1 **Q. (Reference Application Schedule B, Lookout Brook Hydro Plant Refurbishment,**
 2 **Table 2, page 92) It is stated “not proceeding with the Lookout Brook Hydro**
 3 **Plant Refurbishment project would pose a High (20) risk to the delivery of**
 4 **least-cost service to customers.”**

Figure 1
Statistical Lifetime of Hydro Generators by Insulation System⁴

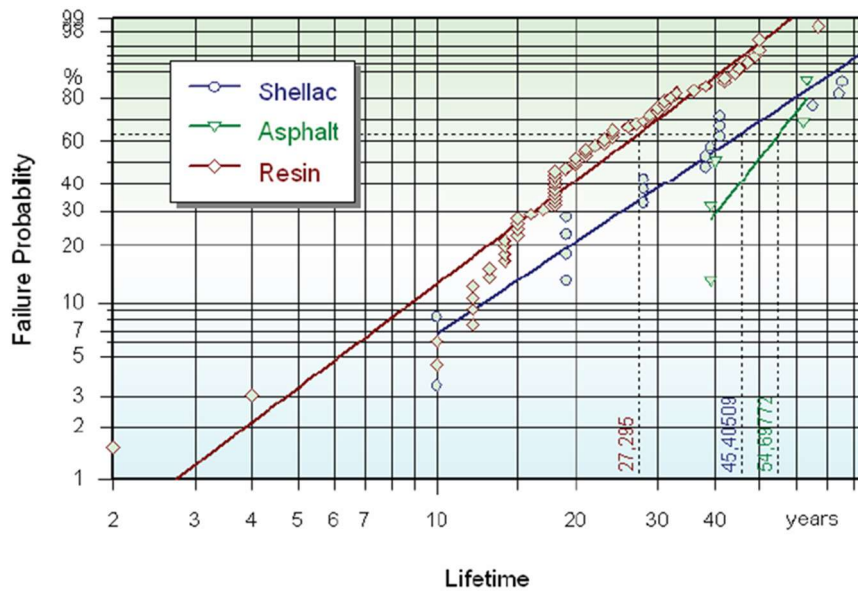
11 **c) The risk assessment in Table 2 indicates that the probability of failure is**
 12 **“likely (4)”. Had the assessment been undertaken 3 years ago would the**
 13 **probability of failure have been ranked “likely”? Three years from now**
 14 **would the probability of failure continue to be ranked “likely” if plant**
 15 **maintenance continues and any failures that arise are addressed under**
 16 **programs designed to address in-service failures?**

6 Figure 1 identifies the probability of failure for different generator insulation systems
 7 as presented in report 4.1.

8 As the figure shows, all winding types experience a high probability of failure
 9 (>80%) in excess of 60 years of age. It is not expected that a significant variation
 10 in probability of failure will occur within any three year period. Newfoundland Power
 11 classifies probability of failure as likely when it is within a range of 76% to 90%.⁵
